**FINDINGS AND RECOMMENDATION
OFFICE OF PLANNING AND ZONING
ANNE ARUNDEL COUNTY, MARYLAND**

CASE NUMBER: 2025-0182-V

REQUEST

The applicant is requesting a variance to allow a dwelling addition (deck) with less setbacks and buffer than required and with disturbance to slopes of 15% or greater on property located at 606B Tower Bank Road in Severna Park.

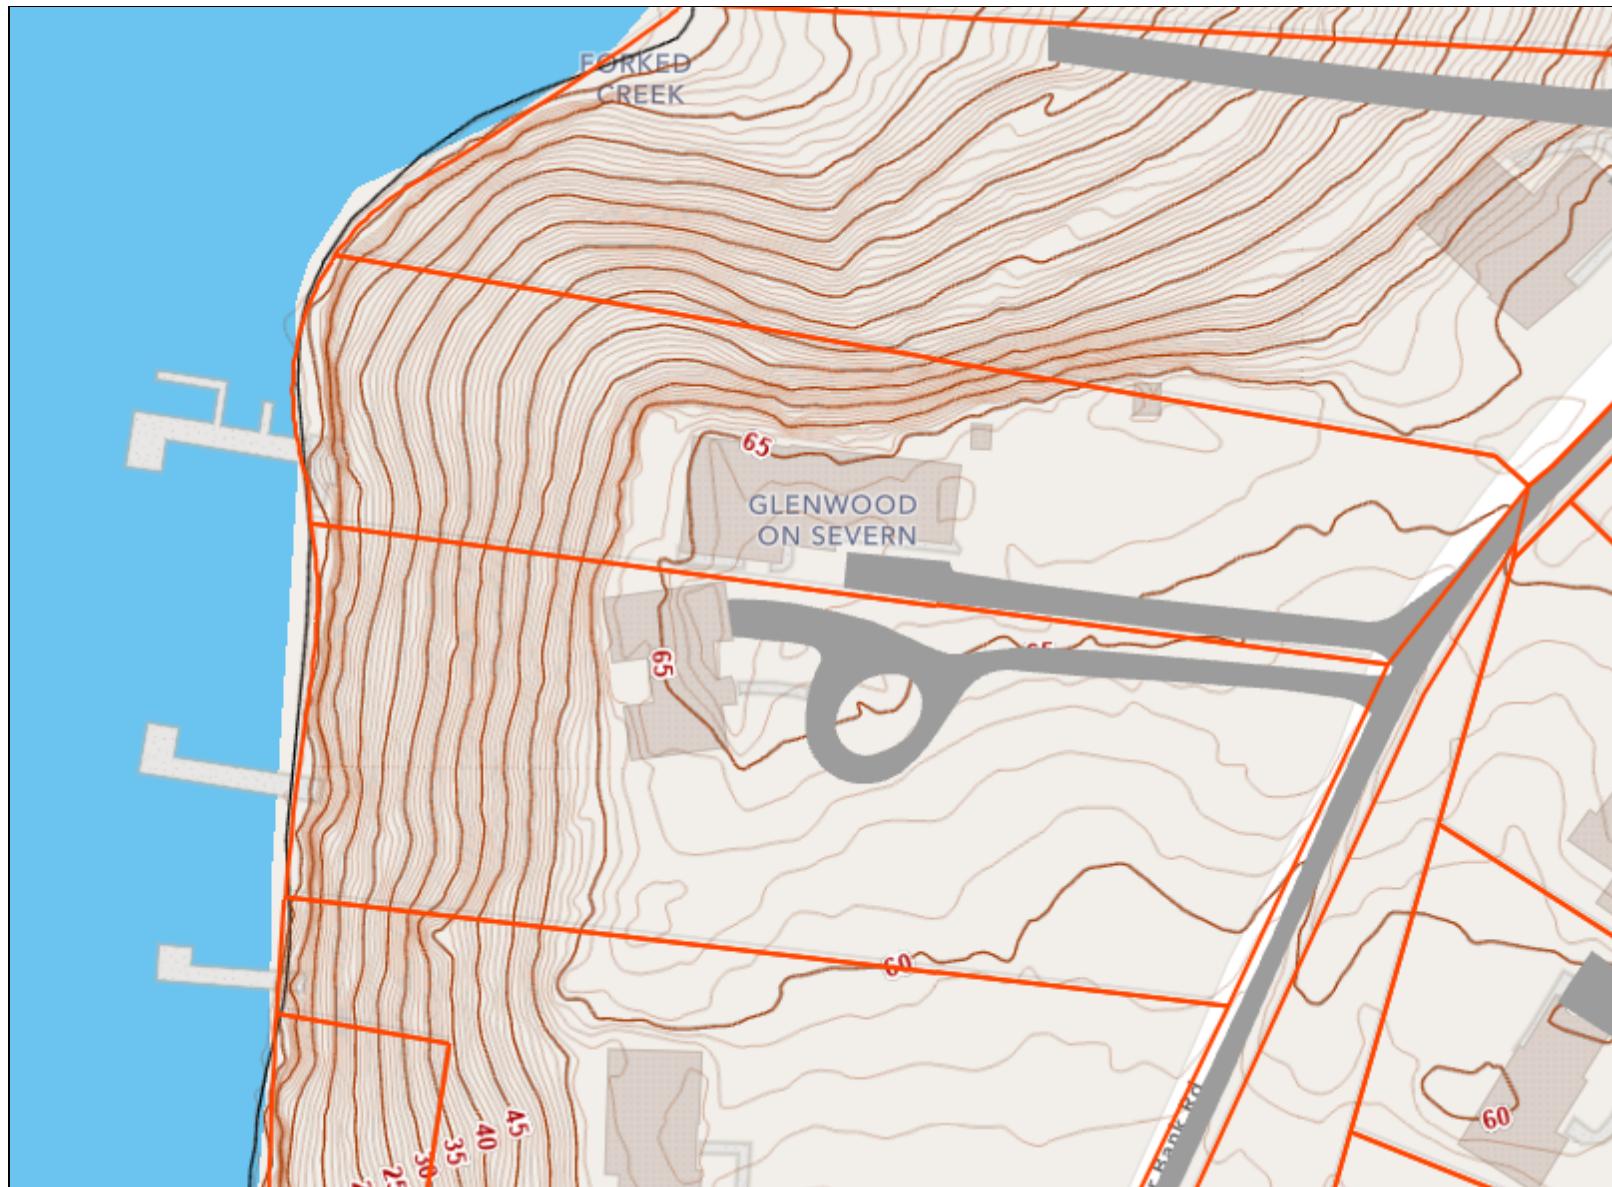
§ 17-8-201(a) of the Code stipulates that development in the Limited Development Area (LDA) may not occur within slopes of 15% or greater unless development will facilitate stabilization of the slope; is to allow connection to a public utility; or is to provide direct access to the shoreline. The proposed deck and its associated Limit of Disturbance (LOD) will disturb slopes of 15% or greater, necessitating a variance to this provision. Exact slope disturbance will be determined at the time of permit.

§ 18-13-104(a) of the Code requires that there shall be a minimum 100-foot buffer landward from the mean high-water line of tidal waters, tributary streams and tidal wetlands. § 18-13-104 (b) provides for an expanded buffer where there are contiguous steep slopes of 15% or more and is to be expanded by the greater of four feet for every 1% of slope or to the top of the slope and shall include all land within 50 feet from the top of the slopes. § 17-8-301 of the Subdivision Code states that development on properties containing buffers shall meet the requirements of Title 27 of the State Code of Maryland (COMAR). § 27.01.01 (B) (8) (ii) of COMAR states a buffer exists

“to protect a stream tidal wetland tidal waters or terrestrial environment from human disturbance.” § 27.01.09 E. (1) (a) (ii) of COMAR authorizes disturbance to the buffer for a new development activity or redevelopment activity by variance. The proposed improvements are located within the expanded buffer, necessitating a variance to this provision. Exact buffer disturbance will be determined at the time of permit.

§ 18-4-501 of the Anne Arundel County Zoning Code stipulates that principal structures in an R1 - Residential District shall be set back a minimum of 15 feet from the side lot lines. The proposed deck will be located as close as 6'6" feet from the southern side lot line, necessitating a variance of 9 feet.

Based upon the standards set forth in § 18-16-305 under which a variance may be granted, this Office recommends **approval** of the proposed variances for the construction of the deck as shown on the site plan.
